DEPARTMENT OF PLANNING AND ZONING PLANNER'S REPORT

DATE: September 11, 2019

RE: Design Review – 449 Walnut Street

The City of Hapeville has received a design review application from Bernard Vigilance for a new single-family dwelling at 449 Walnut Street. The dwelling will have four finished bedrooms and three finished bathrooms, as well as two unfinished bedrooms and two potential bathrooms in the basement. The structure will be built on a hill, with a height of 1.5 stories at the front and 2.5 stories in the rear. The dwelling will have 2,337 SF of heated floor area, a 1,358 SF unheated basement, and a 484 SF two-car attached rear garage, with a total roofed area of 4,275 SF including a porch. The floor plan is mirrored by 451 Walnut Street.

PROPOSED EXTERIOR ELEVATIONS

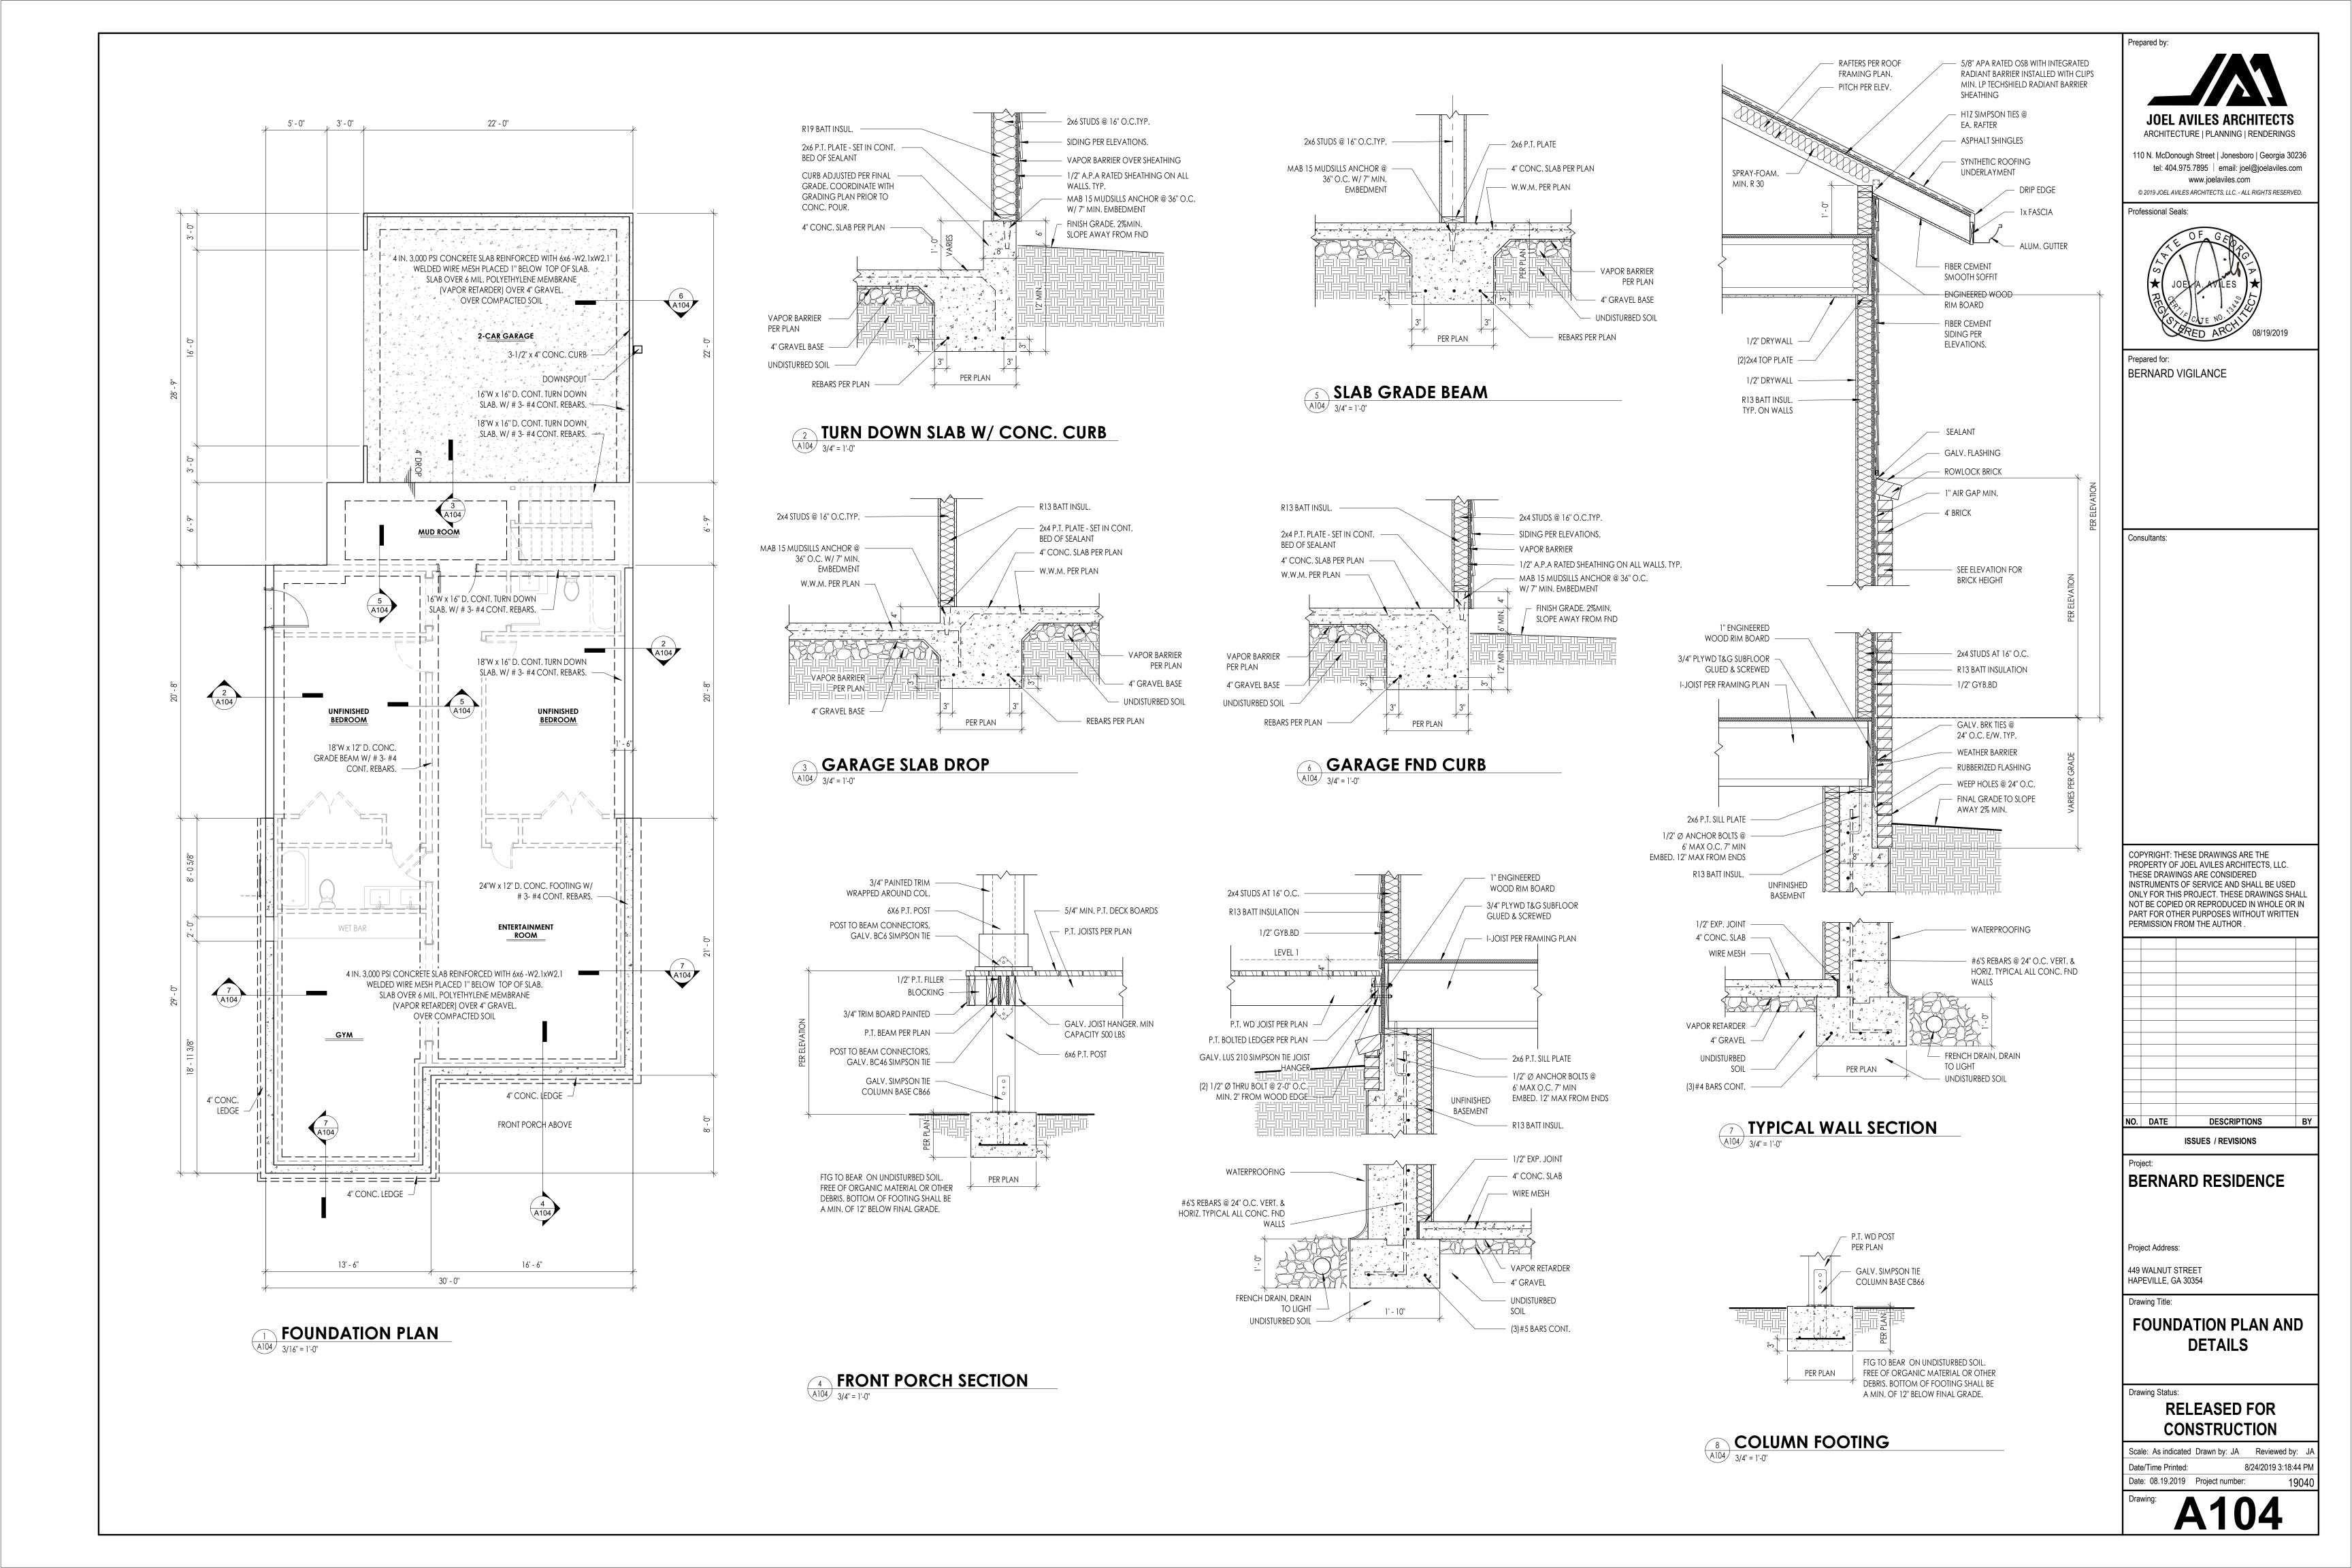
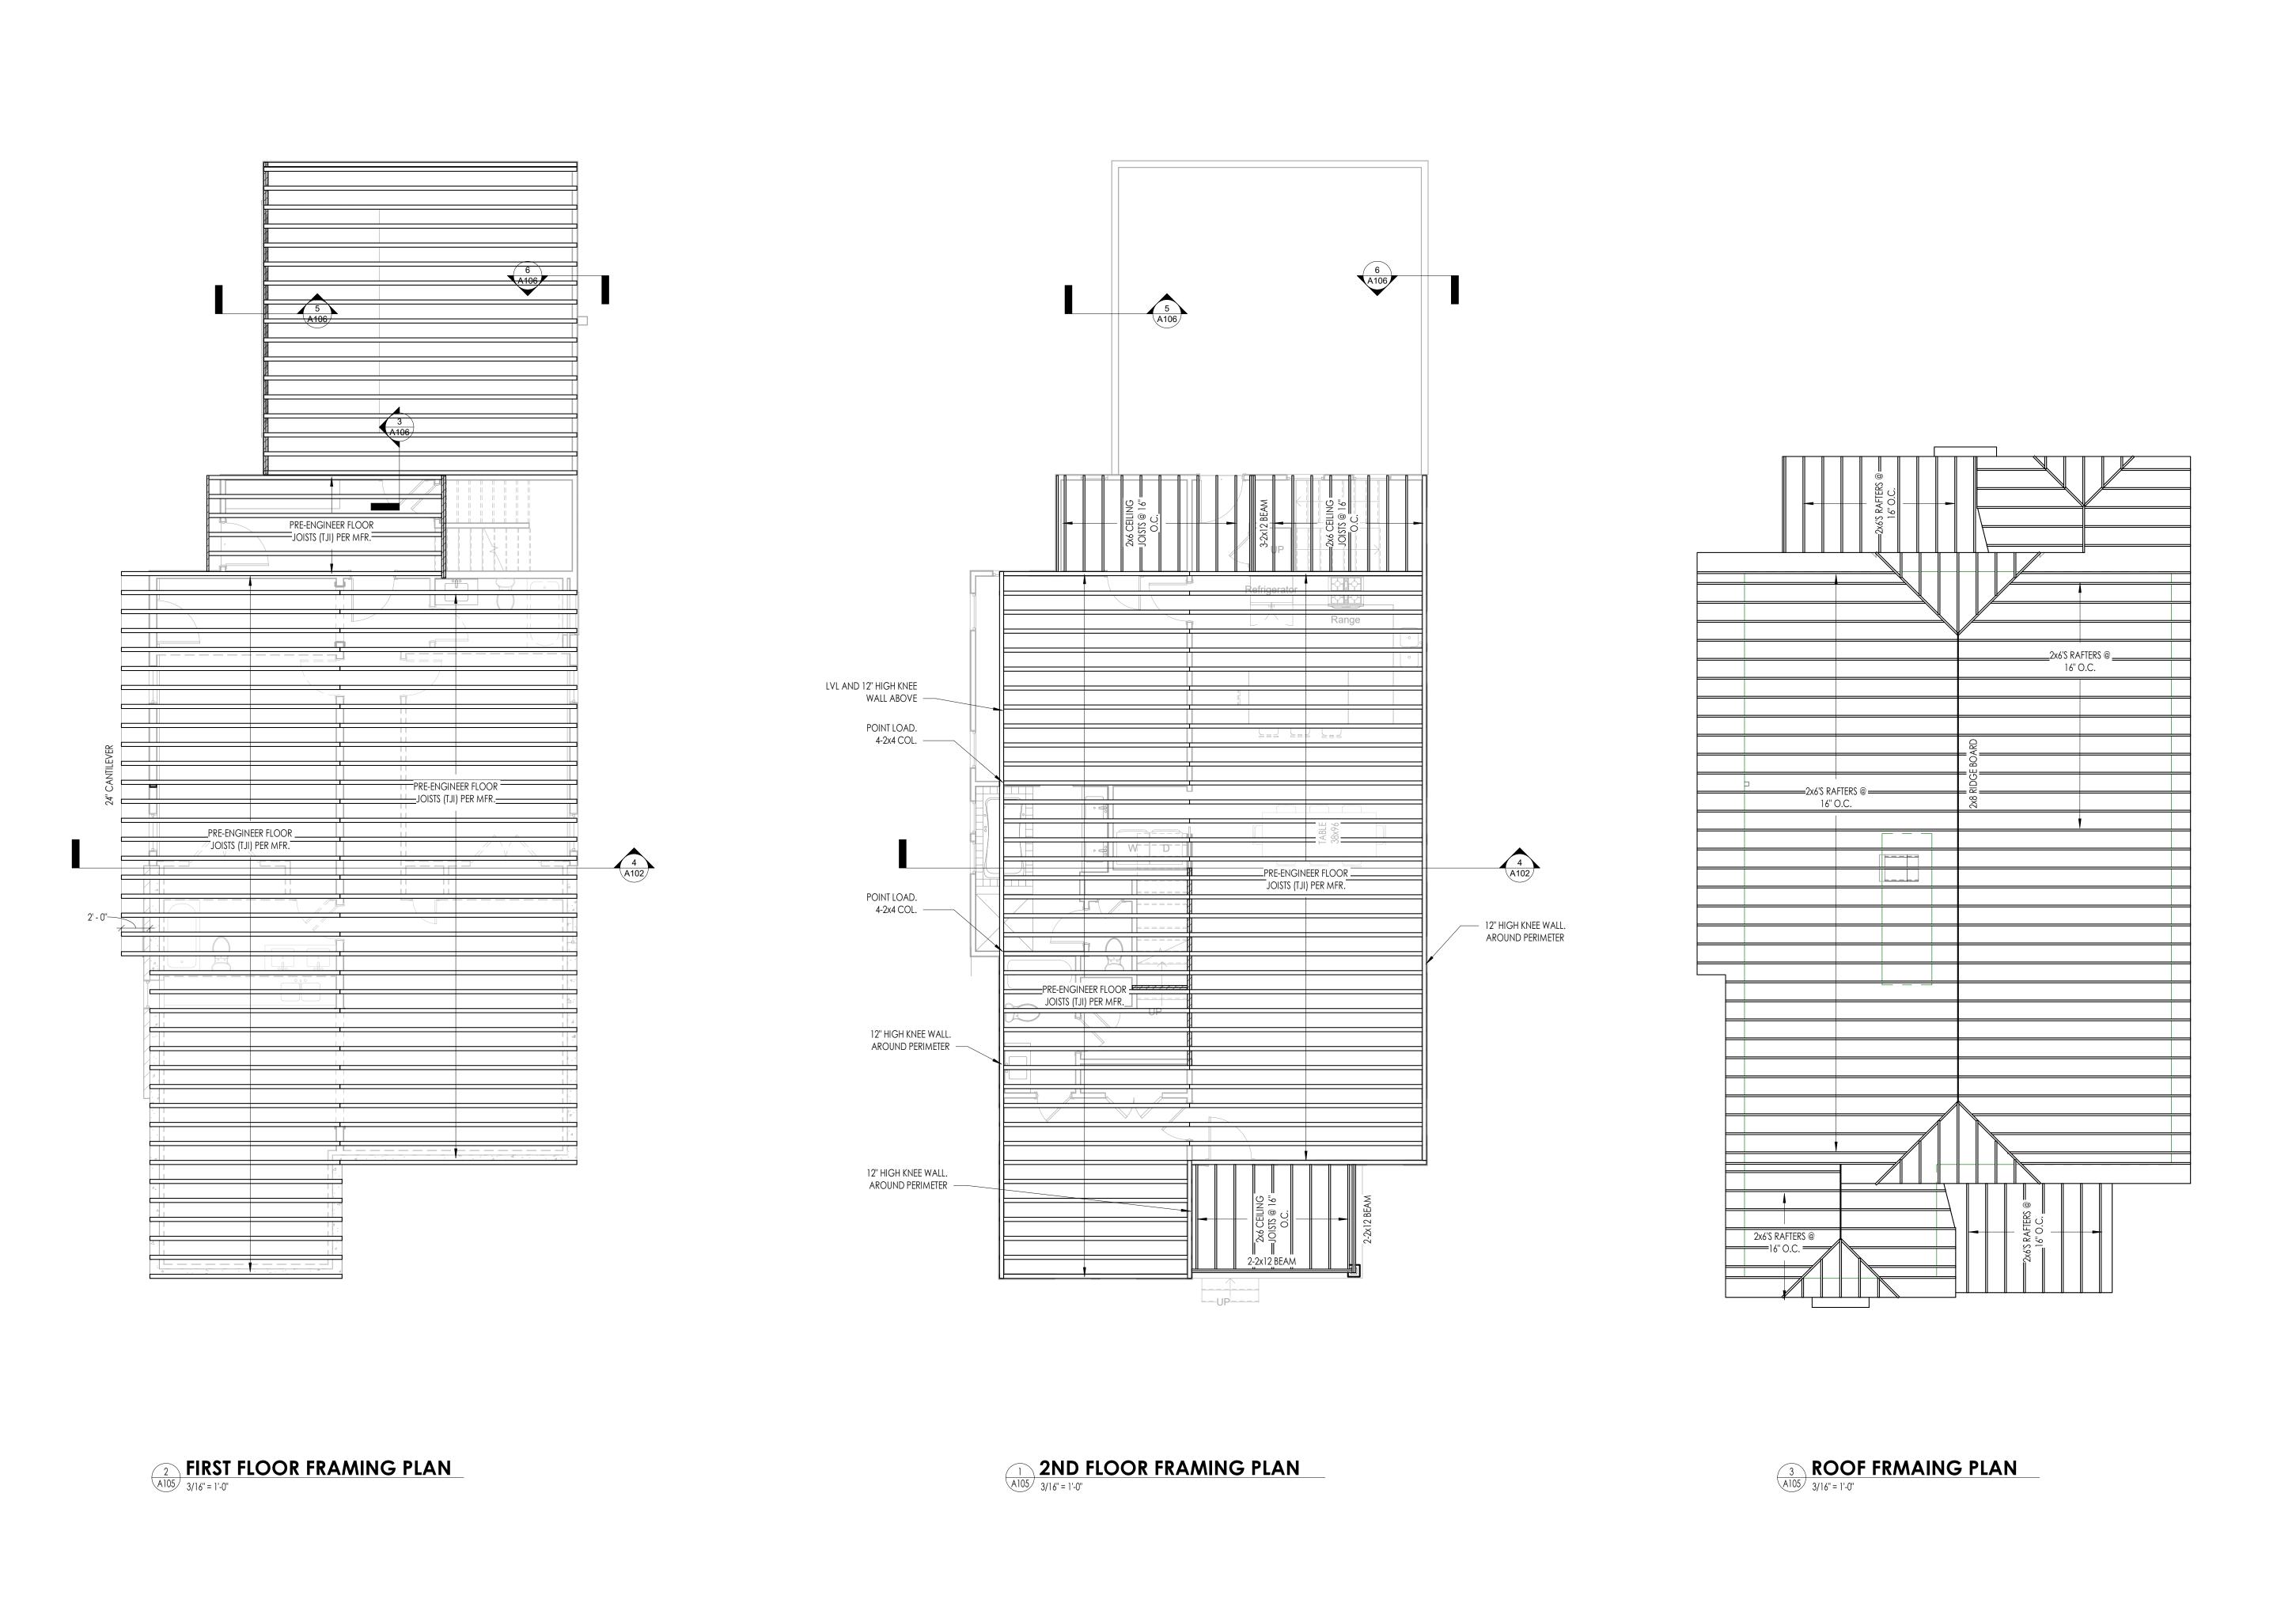
- The applicant should specify the material used for the porch and porch column.
- The porch foundation must be enclosed.
- Porches and finished first floors must be raised between 2' and 4' above grade, unless existing topography is greater. The applicant should provide the height of the porch and finished first floor from grade at the front.
- Front porch widths must be 80-100% of the adjacent façade. The proposed porch is 73% of the width of the adjacent façade/40% of the overall front façade, which is not compliant.

- Building numbers at least 6" in height on the porch or adjacent to the front door should be included and shown on the plans.
- The applicant should ensure no GBGs will be utilized.
- Wooden window trim between 4" and 6" wide and at least 1/4" thick is required around all windows. Note that mullions between grouped windows must be 2" wider than side trim.
- Windows must be provided for 30-50% of the street facing façade. The window coverage of the street facing façade cannot be calculated. The applicant should provide the width of the door glass.

- The applicant should provide the height of the finished first floor above grade, ensuring it is between 2' and 4'.
- Enfronting first story windows must be between 2.5 and 3.5' above finished first floor elevation. The proposed enfronting windows are 2' above the floor, which is not compliant.
- The design does not reflect any of the principal traditional styles found in the community.
- Outbuildings. In conventional development, outbuildings are often designed and located as an afterthought. Yet in traditional towns and cities, outbuildings serve to enrich the quality of design through their placement, design and use. In Hapeville, where outbuildings are provided on many residential lots, their design must be to the same high standards found in the community's neighborhoods.

- 10. Front porch widths must be 80-100% of the adjacent façade. The proposed porch is 73% of the width of the adjacent façade/40% of the overall front façade, which is not compliant.

- 14. Windows must be provided for 30-50% of the street facing façade. The window coverage of the street facing façade cannot be calculated. **The applicant should provide the width of the door glass.**

- a. Windowpane recession from adjacent facades
 - b. Windowsill materials
- 16. Enfronting first story windows must be between 2.5 and 3.5' above finished first floor elevation. The proposed enfronting windows are 2' above the floor, which is not compliant.
